ISO/IEC JTC 1/SC 25/WG 3 N 821

TITLE: Liaison report from ISO/IEC/JTC 1/SC 25/WG 3 to

IEEE 802.3 on Update on cabling issues to support

IEEE P802.3at PoEP

Figure 7 – Equipment and test interfaces

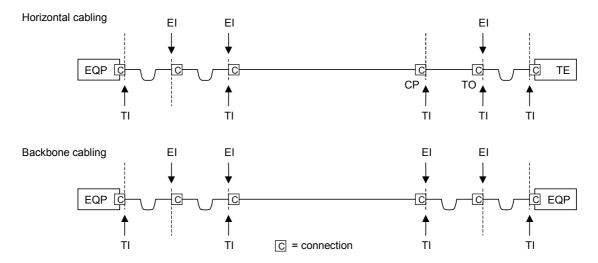
IEEE 802.3 question 1: The actual channel loop resistance is a topic of debate, and IEEE would appreciate some guidance for Medium Dependent Interface (MDI) to MDI links on what the loop resistance applies to and applicable operating conditions.

SC 25/WG 3 response 1: Please see ISO/IEC 11801 Ed2 channel definition and drawings (clause 3.1.15 and figure 7 are attached as Annex 1). Figure 7 shows where the channel exactly starts. Please also see Annex 2, MICE table, and note that MICE 1 is for the general commercial office environment. Class D 2002 DC loop resistance is 25 Ω , and Class D 1995 was specified at 40 Ω at 20 °C.
